TENANT IMPROVEMENT FOR:
CENTRAL VALLEY AUTISM PROJECT
5501 ANTOINETTE ROSE WAY
RIVERBANK, CA 95367

PROPOSED FLOOR PLAN

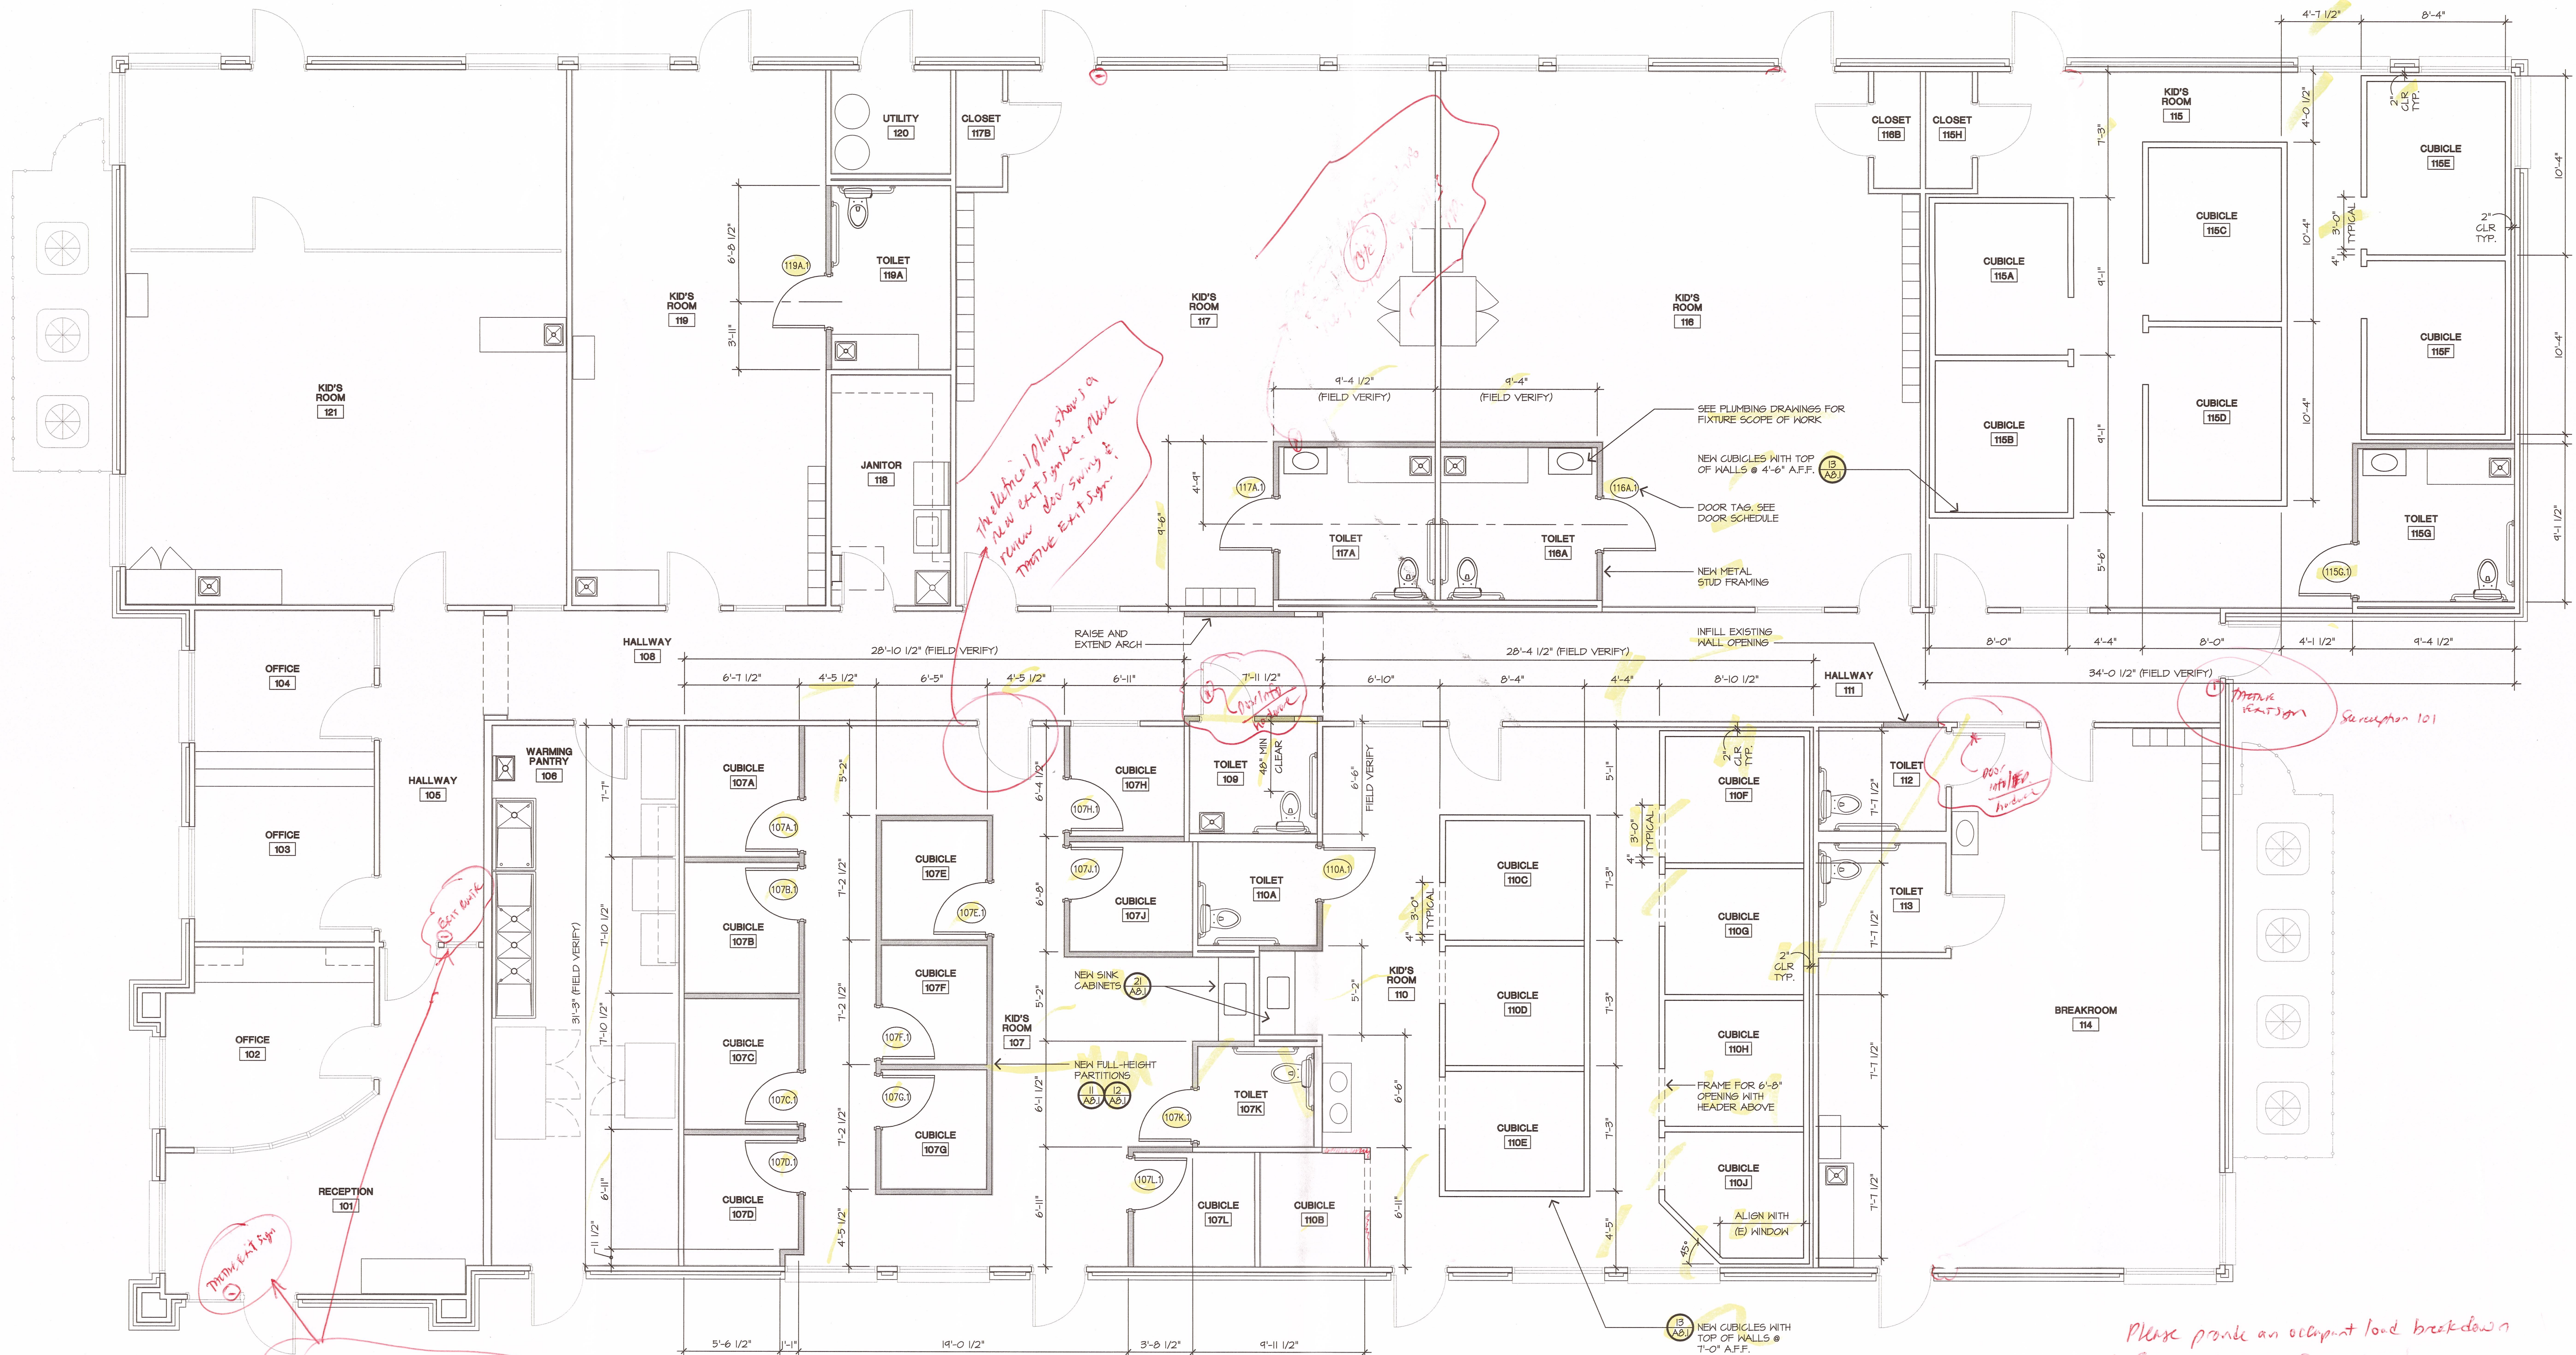
Provide tactile exit signs @ Hallway & reception door exits (3) and any spaces w/ an occ load requiring 2 exit doors. CBC 1011.3
Detail heights & location per CBC 110-103.

Please note: "See sheet A8-1 for Toilet, Lav & Synch accessibility details."

Please provide an occupant load breakdown for the proposed floor plan.
If 2 exits required from space revise existing to comply:
• door swing
• tactile exit sign
